CHAMPION AEROSPACE, INC.

SERVICE LETTER

NUMBER: SL28VS200Y4DH-24-04-001

SUBJECT: Electrical Power - DC Generation - Transformer Rectifier Unit (TRU) Fan Motor Upgrade

Figure 1. Original Fan Motor Assembly Removal

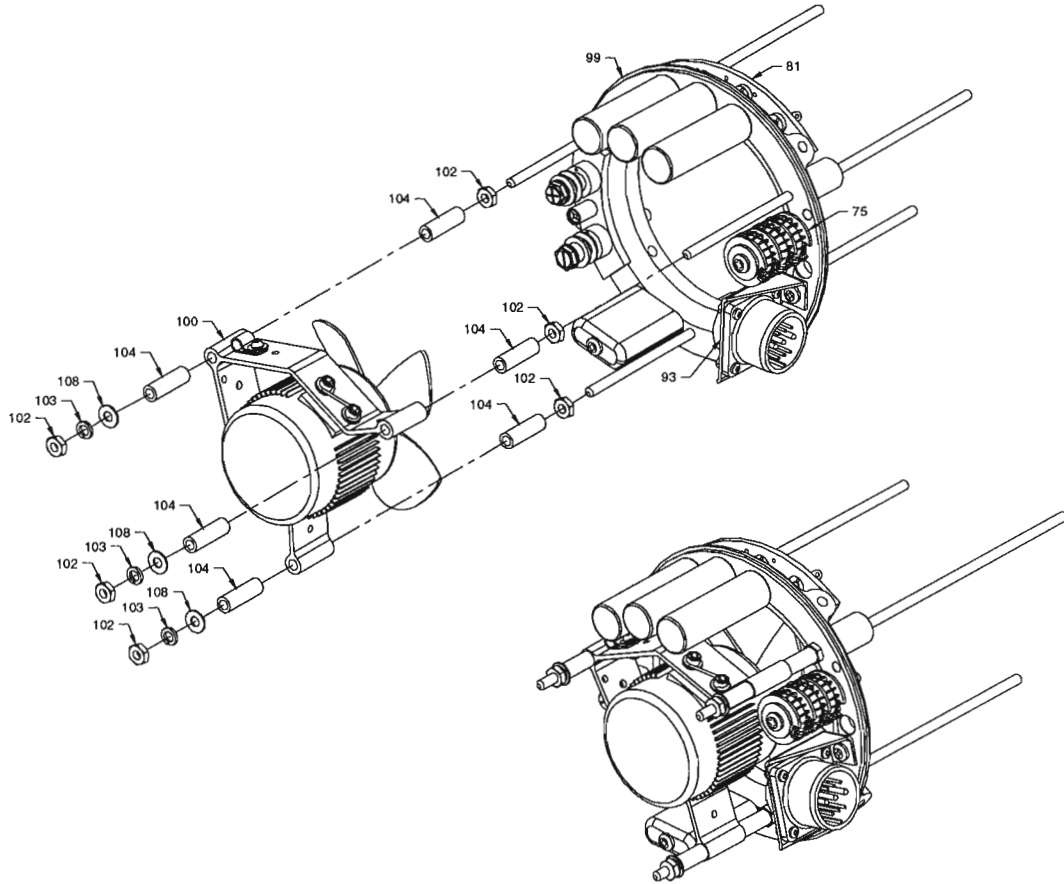
B. Disassembly - Remove Original Fan Motor Assembly (P/N:2561613).

NOTE: During removal of original fan motor assembly, it is not necessary to remove the input connector (93) or the reactor (75).

- (1) Remove mounting base (3), end bell (1) case assembly (6) and Nomex paper (if supplied) in accordance with IPL, Figure 1 of Component Maintenance Manual 24-31-46.
- (2) Remove original fan motor assembly (100) wire lugs (112) from AC Terminal Board (81).
- (3) Remove three nuts (102), three lockwashers (103), three flat washers (108) and three spacers (104) from original fan motor assembly (100) as illustrated in Figure 1.
- (4) Remove original fan motor assembly (100) from tie bolts (101).
- (5) Remove remaining three spacers (104) and nuts (102) from tie bolts (101).

NOTE: Retain all hardware removed during disassembly for subsequent use during assembly of new fan motor assembly.

Figure 2. New Fan Motor Assembly Installation.

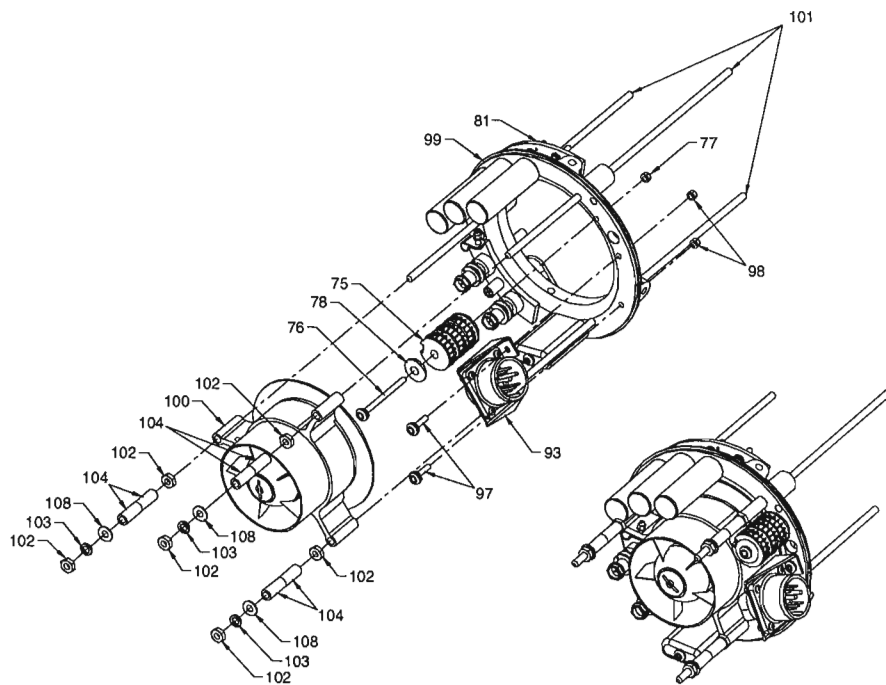
C. Assembly - Install New Fan Motor Assembly (P/N: 2031526).

NOTE: Prior to assembly of new fan motor assembly, it is necessary to move the input connector (93) and reactor (75) aside. Desoldering the electrical connections is not required. Refer to Figure 2.

- (1) Remove two screws (97) and two nuts (98) securing input connector (93) to motor ring (99) and set input connector (93) aside.
- (2) Remove screw (76), washer (78) and nut (77) securing reactor (75) to motor ring (99) and set reactor (75) aside.

- (3) Install new fan motor assembly (100) (P/N: 2031526) onto tie bolts (101).
- (4) Assemble three plain nuts (102) onto tie bolts (101) immediately following the new fan motor assembly (100). Torque to 24-26 in-lbs.

- (5) Install six spacers (104), three flat washers (108), three lockwashers (103) and three plain nuts (102) onto tie bolts (101). Torque to 24-26 in-lbs.

- (6) Position reactor (75) onto motor ring (99) and install screw (76), washer (78) and nut (77).
- (7) Position input connector (93) onto motor ring (99) and install two screws (97) and two nuts (98).

Figure 3. New Fan Wire Routing and Locations.

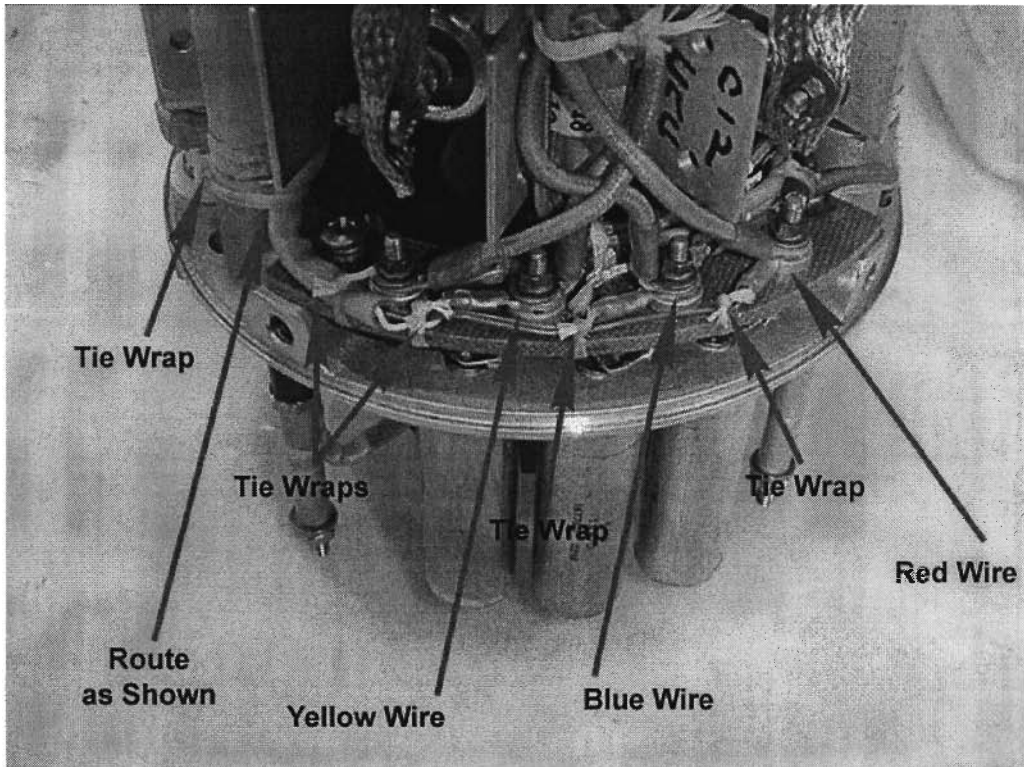
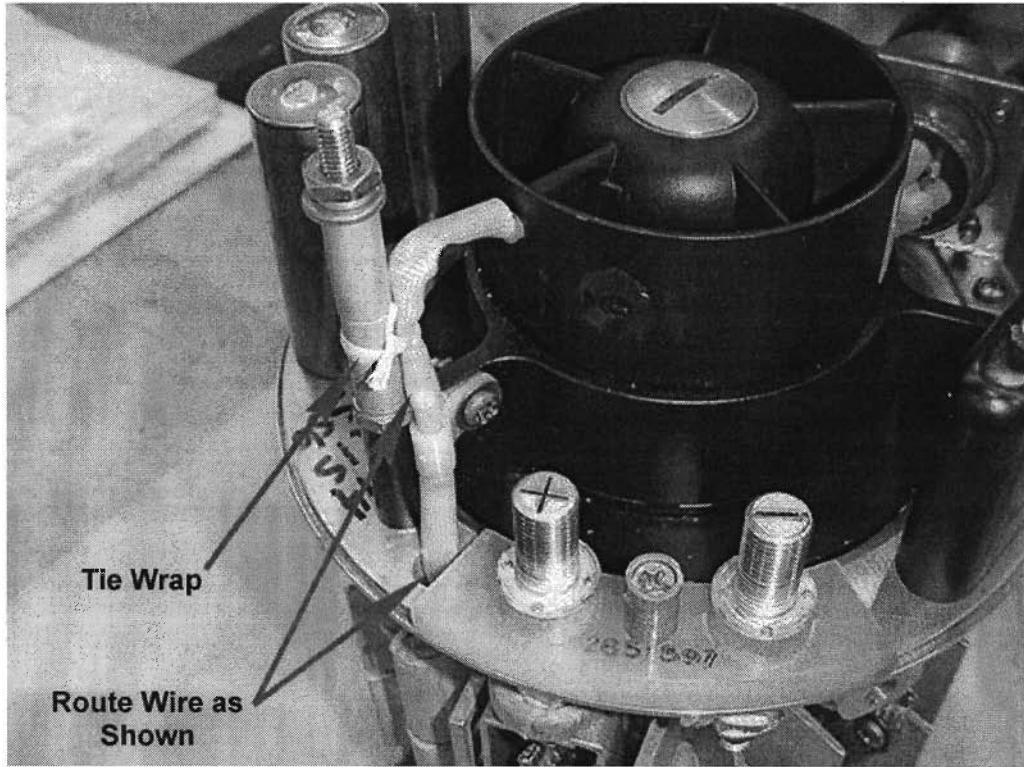
NOTE: THE WIRE COLOR SCHEME HAS CHANGED. PLEASE REFER TO THIS SERVICE LETTER FOR THE PROPER WIRING INSTRUCTIONS.

- (8) Install fan wire lugs (112) from new fan motor assembly (100) (P/N: 2031526), to AC terminal board (81). See Figure 3 for view of proper wire routing and termination.
